ADDENDUM NO. 002
Re: Milton Library – 855 Mayfield Way, Milton GA

SUBJECT: RFI001 Response

PROJECT: Milton Library

LINE C - HGL CHART & PIPE CALCULATIONS

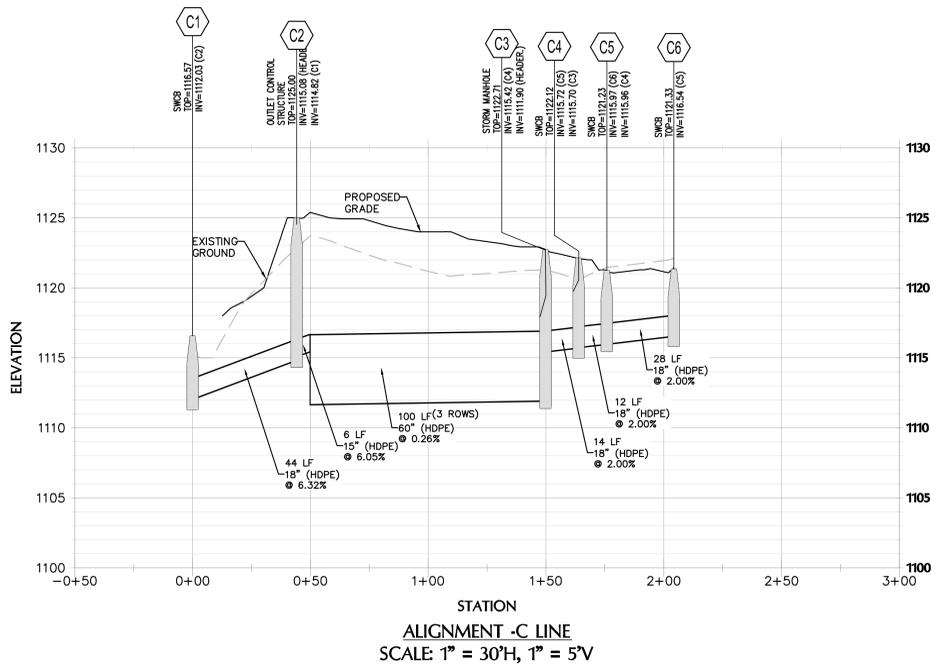
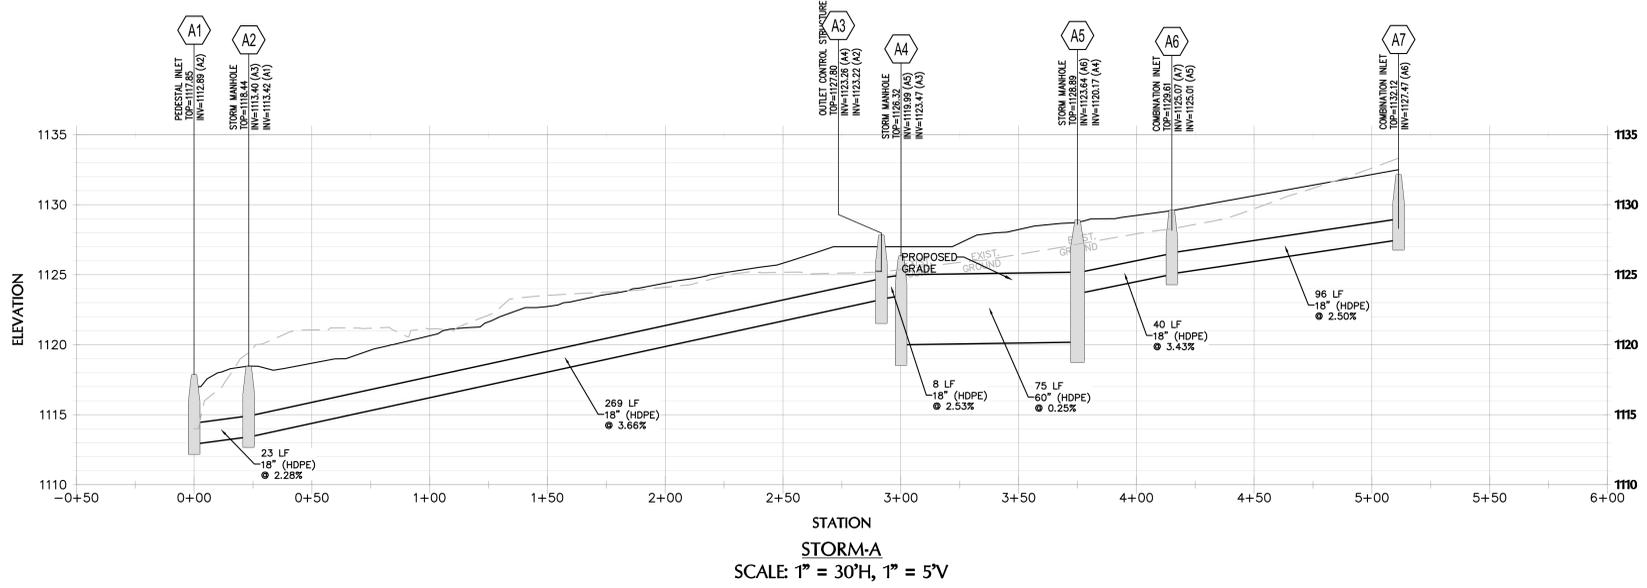
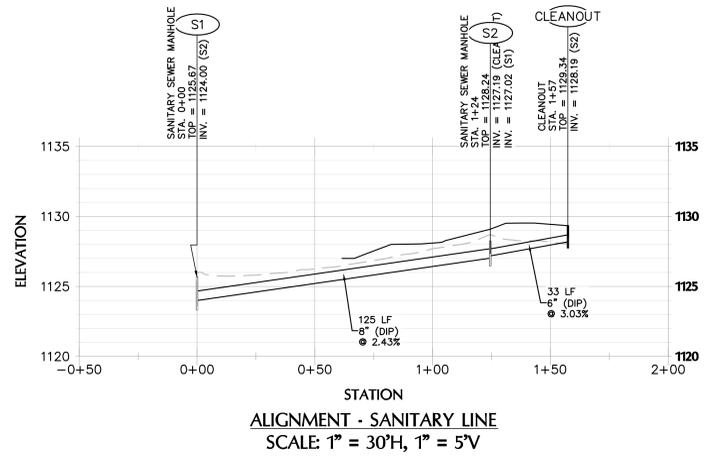
Q. Are there any profiles for the storm drains?

A. See attached sheet C01.6 – Storm Profiles

Figure 3. Typical Porous Asphalt Pavement Section (diagram adapted from US EPA)

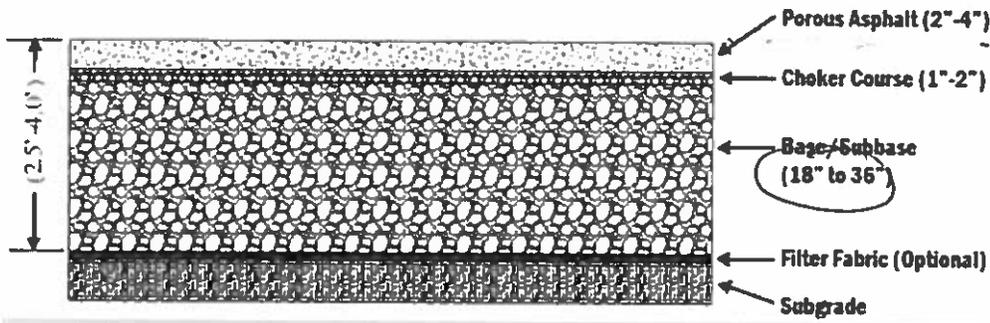
Q. There is no indication on material for the underground detention, what should it be?

A. See attached detail section of the porous asphalt typical section
